This document contains FAQs that were approved since the last revision of NEI 99-02. The following table has the most recently approved FAQs toward the top of the list.

## FAQs - By Cornerstone/PI

Page F-55, Figure F-1

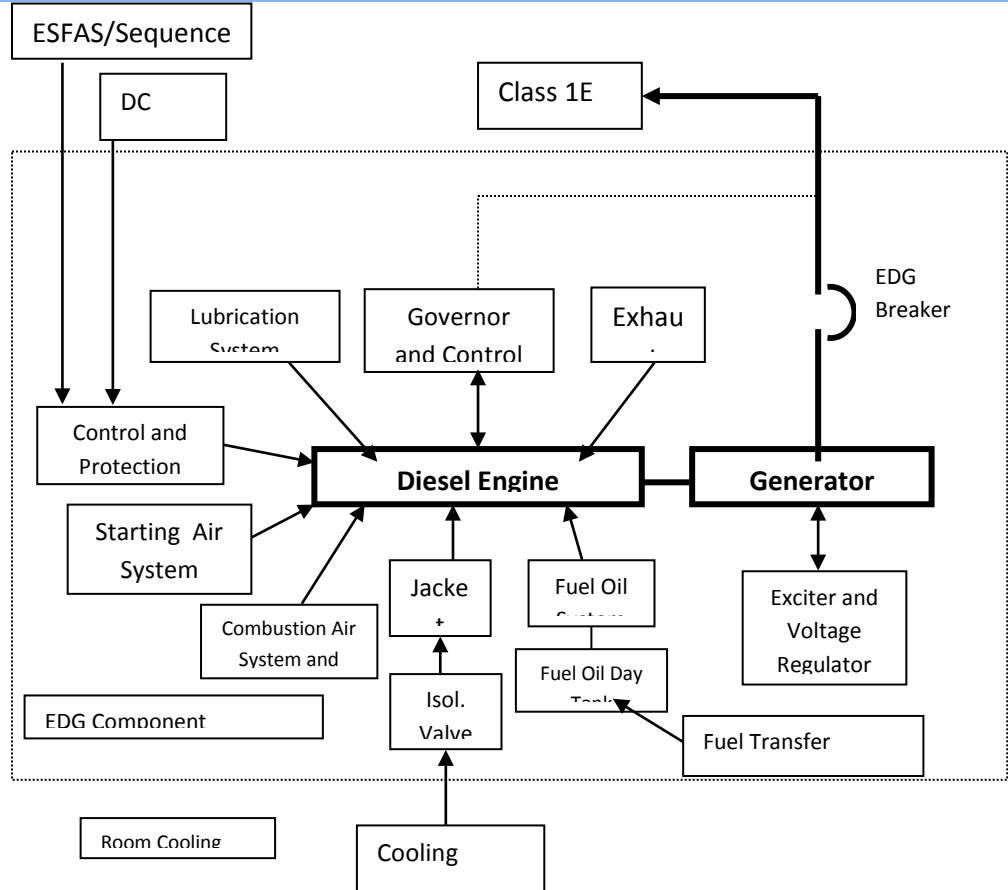
The fuel transfer pumps required to meet the PRA mission time are within the **EDG component** system boundary but are not considered to be a **separate** monitored component for reliability monitoring in the EDG system. Additionally they are monitored for contribution to train unavailability only if **the fuel oil transfer pump(s) is (are) required to meet the EDG mission time (as specified in Section F.2.2.2 and as defined in the MSPI Definition of Terms section)**. ~~an EDG train can only be supplied from a single transfer pump. Where the capability exists to supply an EDG from redundant transfer pumps, the contribution to the EDG MSPI from these components is expected to be small compared to the contribution from the EDG itself. Monitoring the transfer pumps for reliability is not practical because accurate estimations of demands and run hours are not feasible (due to the auto start and stop feature of the pump) considering the expected small contribution to the index.~~

Figure F-6

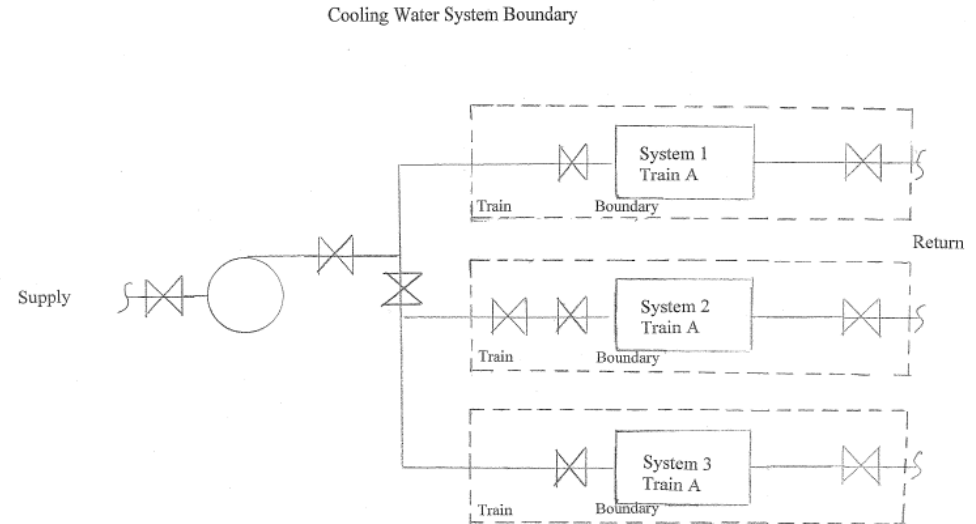
Pumps, valves, heat exchangers and line segments that are necessary to provide cooling to monitored trains or segments of system(s) supported by the cooling water system are included within the cooling water system boundary up to, but not including, the isolation valve(s) that connects the cooling water system to components in a single monitored train or segment of the supported system. This isolation valve is included within the boundary of the monitored train or segment of the supported system. The last valve(s) that provides cooling to SSCs in more than one monitored train or segment of supported system(s) is included within the boundary of the cooling water system. All valves (e.g., manual isolation valves or motor operated valves) in a cooling water line to a single monitored train or segment of a supported system are included within the boundary of the monitored train or segment of the supported system. Figure F-6 depicts this concept and the treatment of multiple isolation valves. The SSCs outside the dashed boxes are included within the boundary of the cooling water system. The SSCs within the dashed boxes are included within the boundaries of the supported systems.

Diagram 1: Low flow area with debris build-up behind Boot

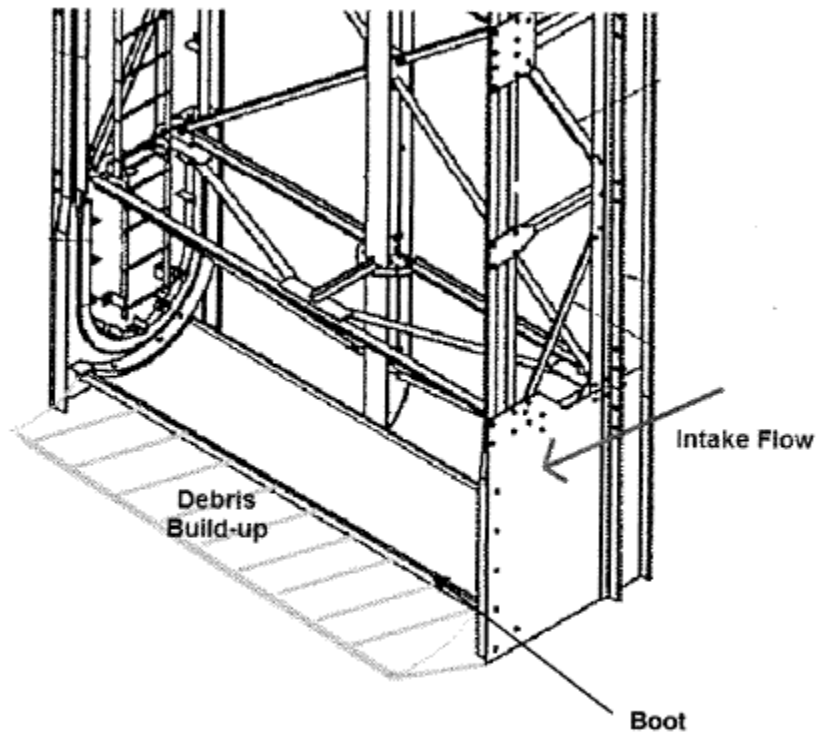
boot. There is a possibility for small debris such as silt, sand, and broken zebra mussel shells to settle in this area south of the screens (pump suction side). In this area, the silt may settle out past the boots and build up to a level to meet up with the process flow. This condition would only take a short period of time to build-up and then would remain in the condition until cleaning could remove the debris.

During normal operation, this debris build-up is not a significant threat to fouling because the debris is settled. However, this area becomes vulnerable when the gates are installed because of the change in flow patterns and increased velocity.

These downpower events should be excluded from the indicator. The licensee had experienced condenser fouling with the original traveling water screen design and although the travelling water screens had been replaced with a new design that previous operating experience was considered in planning the work on the new screens. The licensee took reasonable steps to prevent intrusion by cleaning the forebays and provided normal operating procedural guidance for monitoring condenser differential temperatures and backwashing the condenser water boxes. Since this was the first time the boot inspections had been performed, there was no way to reasonably anticipate that the debris south of the travelling water screens would have been sufficient to cause the observed condenser fouling. In addition, the on-line schedule for that week had a contingency action to perform a downpower in order to support backwashing activities. This was shown as a contingency because there is no way to accurately predict if the condenser will foul or the speed with which it will reach a point requiring a downpower.

**Figure 1, Load and current profile during DG3 Operation on 2/28/10**

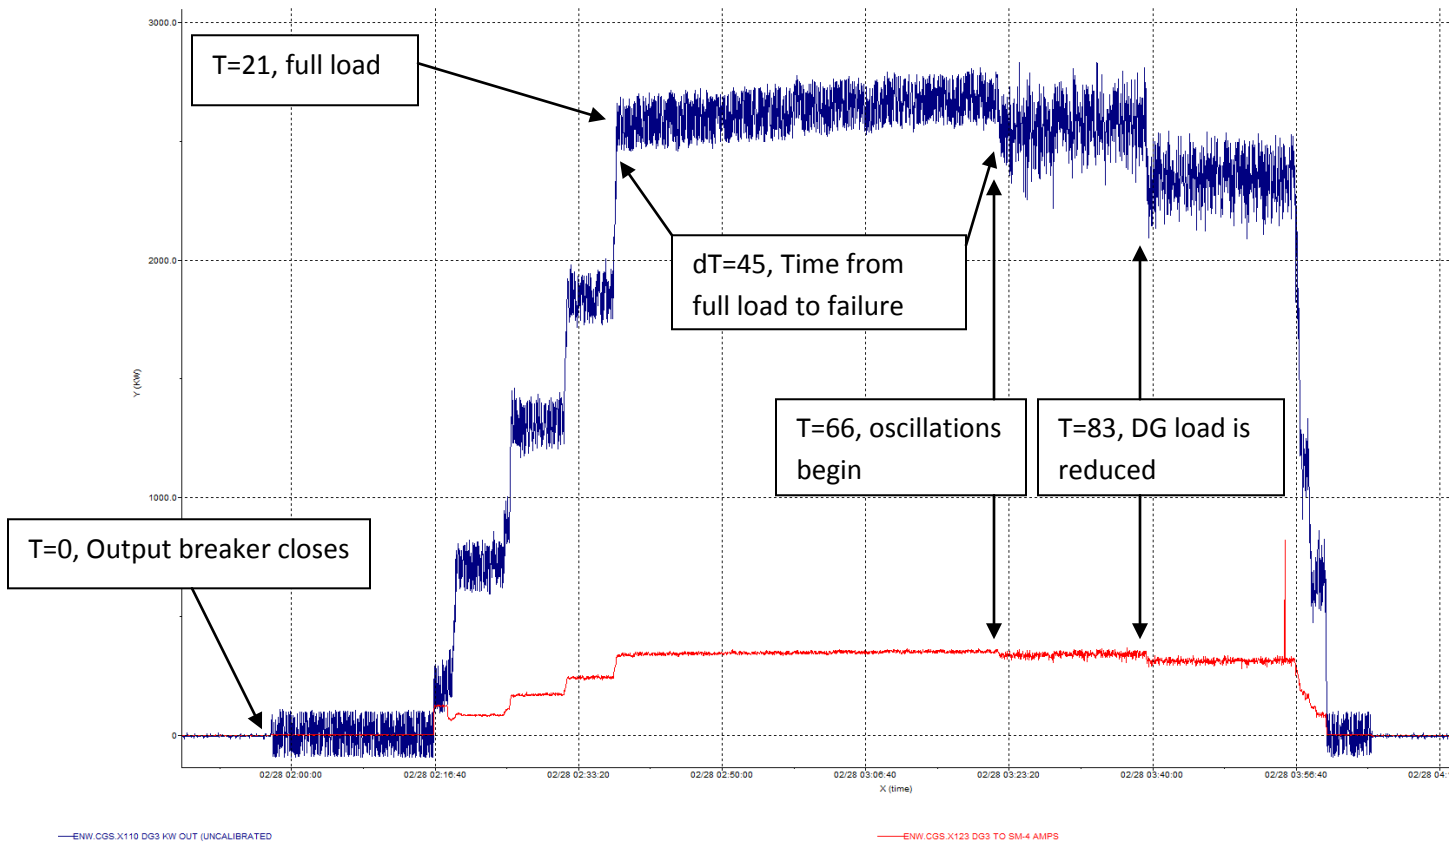
On February 28, 2010, CGS was testing an Emergency Diesel Generator (EDG). Refer to figure 1 for Load and Current trace of the subject event. The EDG successfully started, the EDG output breaker successfully closed (T = 0 minutes), the EDG successfully load sequenced up to fully loaded (T = 21 minutes), after 45 minutes the EDG experienced unexpected load oscillations of 350 kw (T = 66 minutes), after 17 minutes the load was lowered (T = 83 minutes) and the 350 kw oscillations were observed to continue another 16 minutes of operation until the EDG was unloaded (T = 99 minutes) and shut down.

The NRC staff evaluated this issue based on the characteristics of the EDG failure (i.e., the functional response of the EDG and the failure mechanism), and applying reasonable decision-making using the guidance in effect at the time of the failure. The oscillations were caused by foreign material in the governor – a condition that had existed for several years and that did not impact prior breaker closure and sequencing operations. Figure 1 in this FAQ shows that the oscillations did not occur during the breaker closure or the load sequencing or gradual loading action. Rather, the oscillations occurred 66 minutes after breaker closure and 45 minutes after the full load (for purposes of the test run) was achieved, which is indicative of a challenge to the EDG’s ability to continue to run for its mission time. Even though the foreign material existed in the governor for several years, the EDG had started and load sequenced several times without failure. Therefore, this failure appears to have been exacerbated by the running (vice start or loading) of the EDG.

Because Figure 1 data is more reflective of an EDG failure-to-run for its mission time rather than a loading failure, the EDG failure at Columbia should have been reported as a failure-to-run.
